Town of Crested Butte Planning Commission Town Council Chambers 507 Maroon Ave; Crested Butte, CO Monday, January 23, 2023

Subject: Public Hearing: Appeal of the Decision of the Town of Crested Butte Board of Zoning and Architectural Review (“BOZAR”) Regarding the Proposed Elk Avenue Quarry Minor Subdivision Located At 15 Elk Avenue (LOTS 19-24, BLOCK 19, CRESTED BUTTE).

Subject: Public Hearing: Referral from the Board of Zoning and Architectural Review (“BOZAR”) for Minor Subdivision with Two Waivers for the Property Located at 601-701 Butte Avenue (Lot TP3 and TP5 Slate River Subdivision).

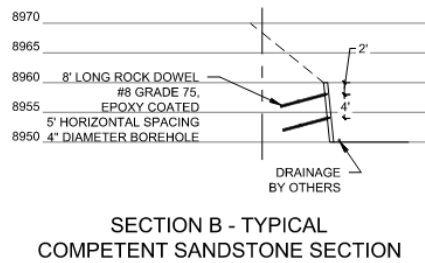
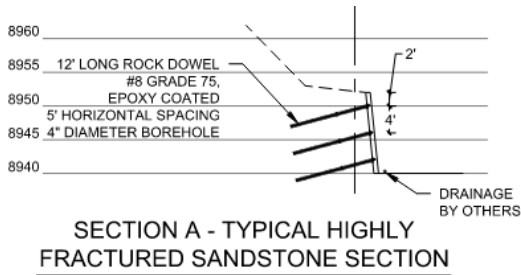
There are two details for the proposed retaining walls, shown in diagrams below. Section A is specific to the west portion of the lot wrapping to the east, parallel to the alley on the North, with a 9' setback from the wall. This wall is proposed to be 12'1" in height with 12' dowels (bolts). The retaining wall labeled Section B would be specific to the southern portion of the lots wrapping to the east, parallel to Elk Avenue on the South, and would have a wall 10'1" height. The adjacent property to the west would not be impacted and the public property to the south would not be impacted.

The proposed Hillside Preservation Covenant addresses the specifics of the rock bolt and any construction needing to happen on Parcel 3. The dowels from the wall for Section A, parallel to the alley, appear to encroach into the alley by 3', confirmation is needed if encroachment is required, if so the applicant will need a revocable license agreement executed with the Town.

2) Section - Main House
1" = 20'-0"

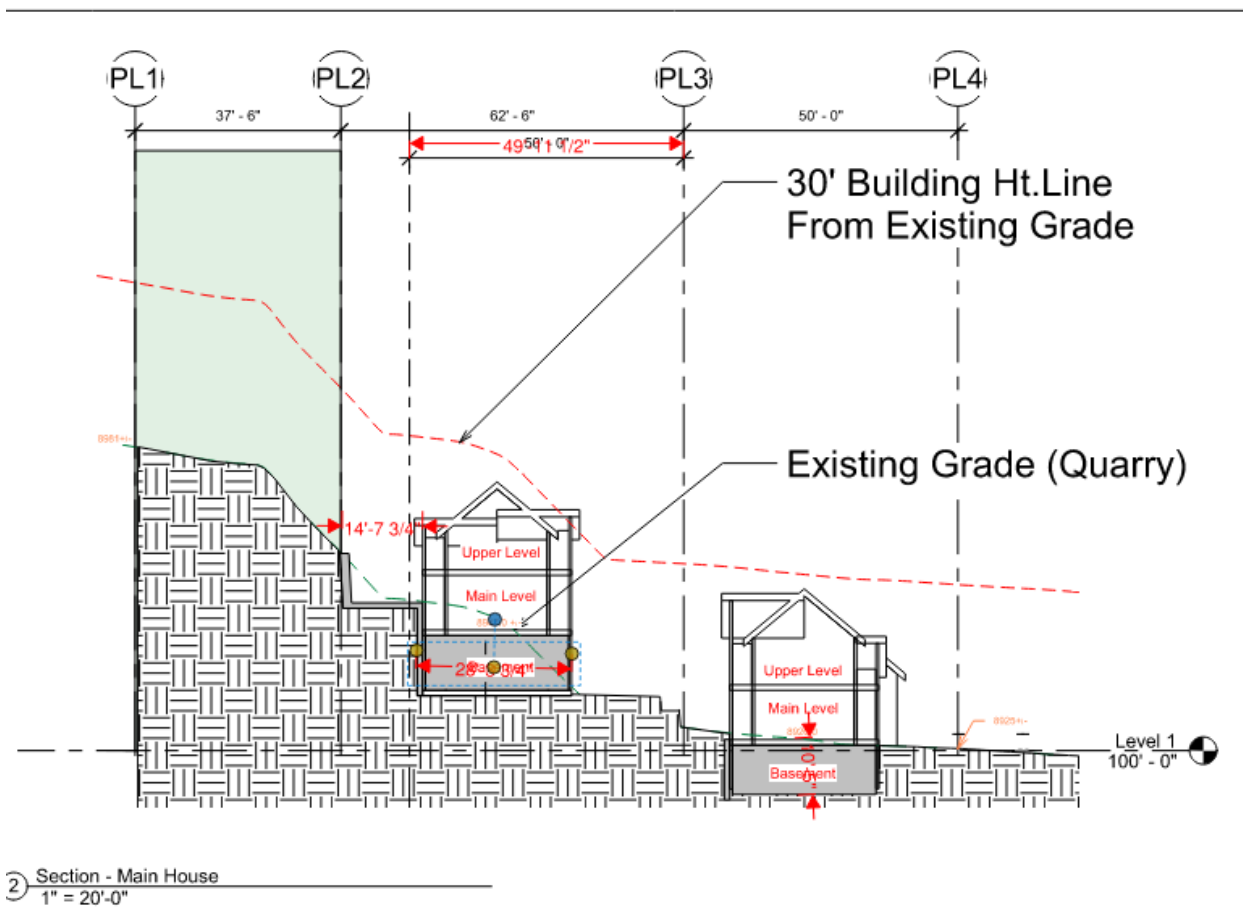
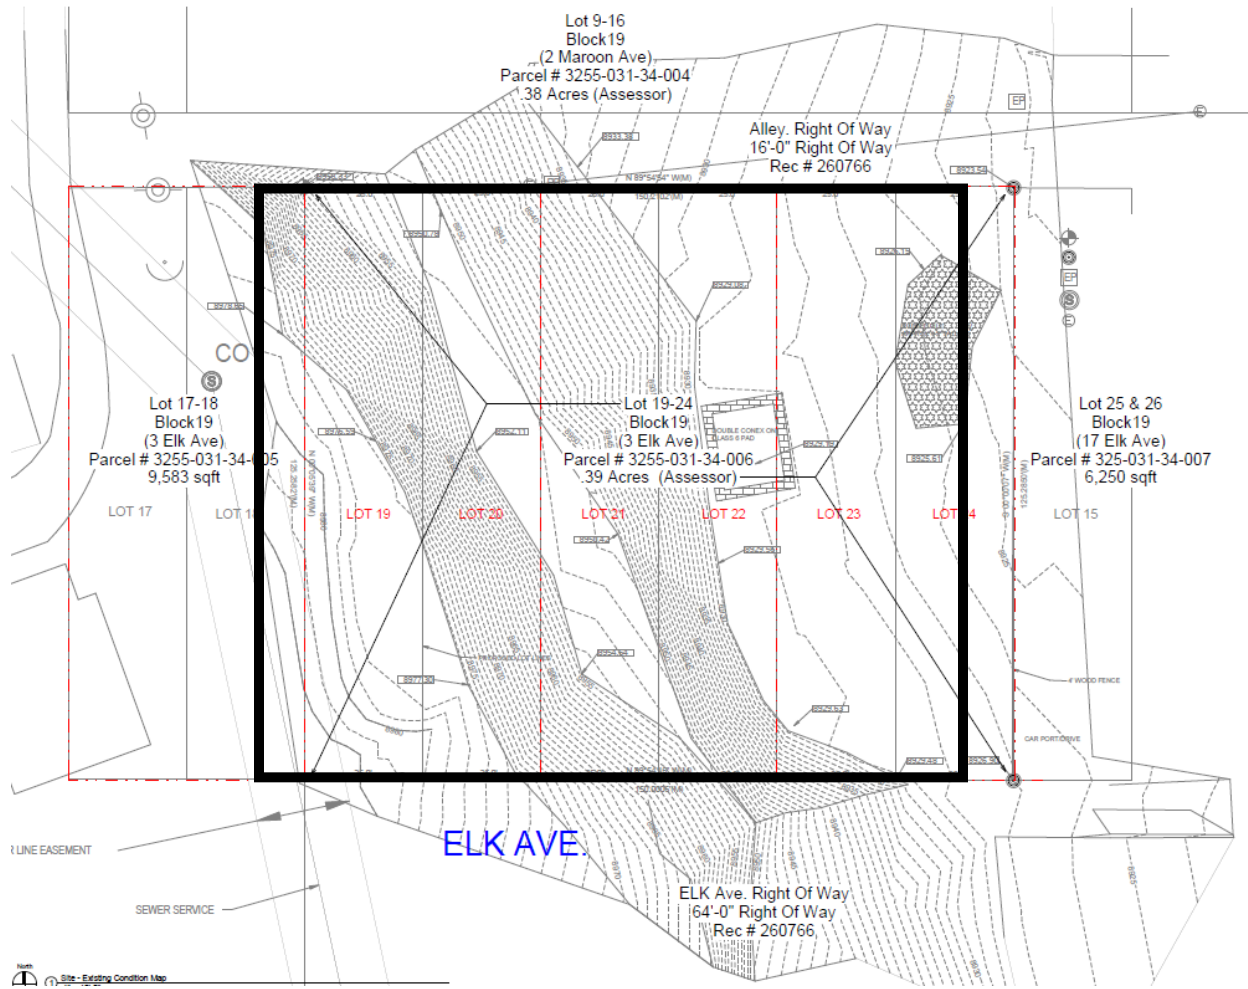
Parcels B proposes to cut into the hillside laterally a rough total of 43' to the west.

Maximum lot size – Parcel B is proposed to be 7,812.5 sf in size, exceeding maximum allowed lot size of 6,250 sf. Note the proposed Floor Area Ratio (FAR) would not exceed the maximum allowable size. All that said, a waiver would need to be approved by the Planning Commission where the applicant provides a public benefit more than Town requirements.

Alternation of Natural Grade (Staff is authorized to determine natural grade if the site has been historically altered. Staff made the determination that the current grade created by the quarry is natural grade.) Parcel B is proposed to have a finished grade up to six feet different from the natural grade, where three feet is the maximum allowed difference between finished grade and natural grade. All that said, a waiver would need to be approved by the Planning Commission where the applicant provides a public benefit more than Town requirements.

Proposed Subdivision

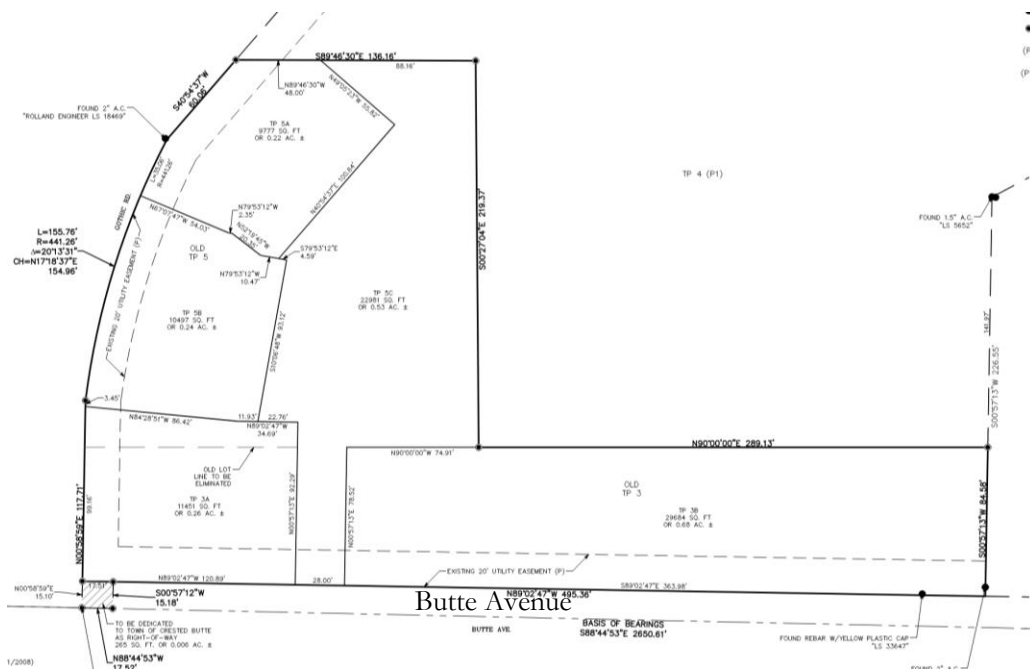
Maximum lot size – All five of the proposed Lots exceed the maximum allowed lot size of 6,250 sf (TP 3A 11,451 sf, TP 5B 10,497 sf and TP 5A 9,777 sf and TP 5C 22,981 sf). Note, the proposed Floor Area Ratio (FAR) of each Lot would not exceed the maximum allowable size.

Alternation of permitted front yard setback for TP5A of 0' (northeast corner) where a minimum setback of 20' is required and alteration of permitted side setback for TP5A northwest (0'-11-6') where a minimum of 7'6" is required.

Staff supports the two waiver requests, as we believe the applicant's proposed public improvements (34 work force housing units) appropriately compensates the community/public. Additionally, the subdivision language in the code was written for rectilinear lots of the traditional town street grid and applies poorly to parcels that were annexed within the Slate River Subdivision. The full reasoning for staff's position is detailed below in reference to Section 17-4-50 (b) Waiver Requests.
